303-24

# **TECHNICAL BULLETIN**

Limited Throttle Opening – Secure Throttle Cable Adjusting Nut – Recall R466 MODEL 1998 MY XK8 Range 1998 MY V8 XJ Series

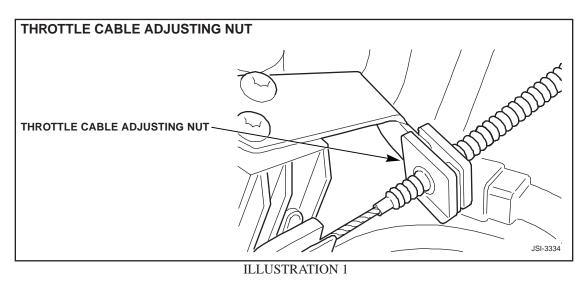
- 1. Open the hood and install protective fender covers.
- 2. All models: Looking into the engine compartment when standing by the left hand front wheel, examine the throttle cable adjusting nut and its bracket. If an existing tie-strap is present as in Illustration 2 below, no further action is required. If no tie strap is present (as in Illustration 1 below) proceed as follows:

- 3. All models: Press the throttle cable adjusting nut fully downwards into the abutment bracket shown in Illustration 1 below.
- Install and fully tighten a tie-strap (Part No. ADU 9028) as shown in Illustration 2, to secure the adjusting nut in its location in the bracket. Trim off any excess from the tie-strap.
  Sedan models only: Reinstall the rear engine cover, tool-box and master cylinder covers.
